SUBJECT : Hyundai ImageQuest Co., Ltd.
FCC ID: PJIL17A00001
FCC Part 15 Subpart B Certification

Transmitted herewith, on behalf of Hyundai ImageQuest Co., Ltd. is an application for a Class II Permissive Change Certification of the following 17-inch LCD Monitor:

FCC ID : PJIL17A00001
Model/TYPE : L17T/ L17A00000

• Solution for EMI

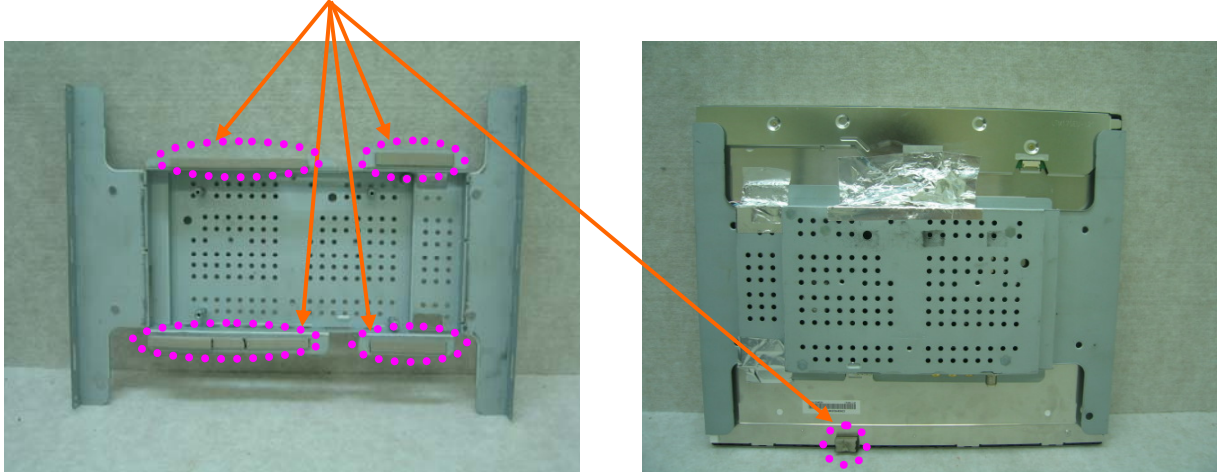
1. Attach a gasket on the main frame to contact the LCD panel

2. Attach aluminum tape on the frame and LCD Rear panel.

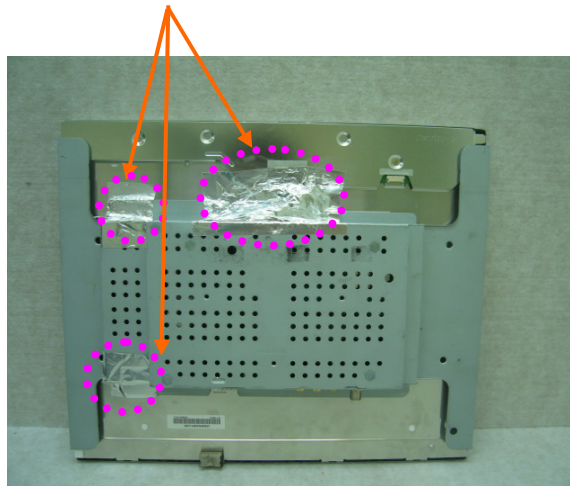
3. Apply a ferrite Core to the OSD cable
